Contract #: 04-0120F4Cty: SF/ALA Rte: 80 PM: 13.2/13.9File #: 69.25B**QUALITY ASSURANCE -- NON-CONFORMANCE REPORT****Location:** Changxing Island, Shanghai, P.R. China**Report No:** NCR-000812**Prime Contractor:** American Bridge/Fluor Enterprises, a JV**Date:** 26-Jul-2010**Submitting Contractor:** Zhenhua Port Machinery Company, Ltd (ZPMC), Changxing Island**NCR #:** ZPMC-0774**Type of problem:**

Reference Description: Weld Repair performed on SPCM Material without Engineer's approval**Description of Non-Conformance:**

To:	AMERICAN BRIDGE/FLUOR, A JV 375 BURMA ROAD OAKLAND CA 95607	Date:	28-Jul-2010
Dear:	Mr. Charles Kanapicki	Contract No:	04-0120F4 04-SF-80-13.2 / 13.9
Attention:	Mr. Thomas Nilsson Project/Fabrication Manager	Job Name:	SAS Superstructure
Subject:	NCR No. ZPMC-0774	Document No:	05.03.06-000770

NCR PROPOSED RESOLUTION

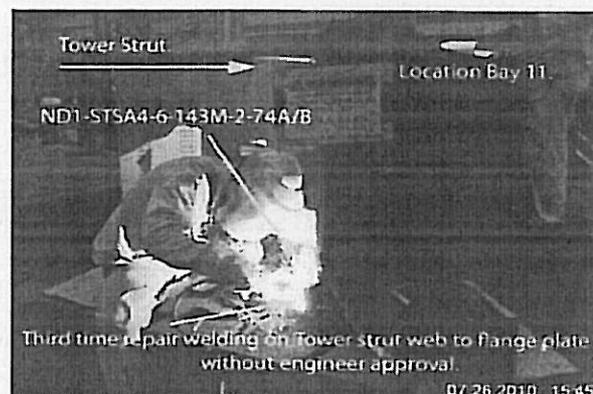
-ZPMC welder personnel is performing Shielded Metal Arc Welding (SMAW) repair on Seismic Performance Critical Material (SPCM) without the Engineer approval.

-The effected Tower Strut identified as ND1-STSA4-6-143M-2, Joint No identified as ND1-STSA4-6-143M-2-74A/B.

-The Material thickness is 32 mm.

-This Tower Strut is located in Sub assembly Bay#11.

For further information, please see the attached pictures below.

Contractor stopped the repair weld and only resume the repair after the CWR approval by Engineer. Contractor will perform NDT after repair to prove the weld is acceptable. Contractor will educate the inspector involved for carrying out critical weld repair without approved by Engineer.

Contractor stopped the repair works immediately. Repair resumed until CWR is approved by Engineer. NDT report submitted subsequently showed that the weld is acceptable. Contractor reprimanded the inspector involved and made him aware of the consequence of repairing with no Engineer's approval.

WELD NUMBER: ND1-STSA4-6-143M-2-74A/B

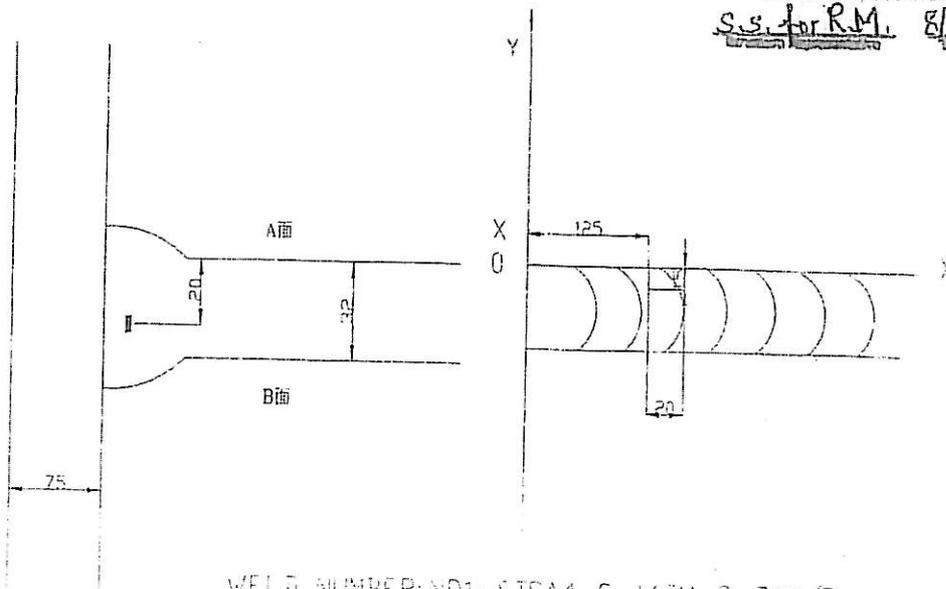
Rejected indication found by ultrasonic inspection at second time.

(UT探伤返修第二次, 并且该板为A709SL-GE485。) ND1-STSA4-6-143M-2-74A/B

1 The weld defect location may not have been properly identified prior to grinding. i.e. the X and Y location was incorrect or the excavation was not centered on the defect, therefore the excavation did not encompass the whole defect

1. QC shall monitor and direct the welder and the grinder doing the repair operation.
2. Preheat before gouging; the temperature shall be at least 65°C.
3. Gouge the weld to remove identified defects.
4. Joint details shall refer to the approved WPS repair.
5. Grind the gouged areas to a smooth and shiny surface.
6. Verify with VT and MT to ensure no defects remain in the weld joint prior to welding.
7. QC shall monitor all welding passes being deposited.
8. QC shall ensure all slag has been removed prior the deposition of next pass.
9. Preheat and maintain interpass temperature control in accordance with the WPS.
10. Blend the weld repaired areas into the adjacent weld or base metal by grinding.
11. Perform VT, MT and UT NDT inspection to the repaired areas.

- QC and production to properly lay out the UT defect, mark the X, Y, D on the base metal and the location on the surface of weld by use of rectangle or circle, by doing this, UT operator will verify the exact location of the defect prior to excavation.
 - The UT operator and or CWI will take the responsibility to verify the excavation has completely removed the defect
- QC和生产部门应该正确的标出缺陷的位置, 在母材上标出缺陷X, Y, D的值, 在焊缝上, 用长方形和圆圈标出缺陷的位置, 这样, 在碳刨前, 能够准确的确认缺陷的位置;
 - UT检验员和CWI必须确认缺陷已经完全刨除.
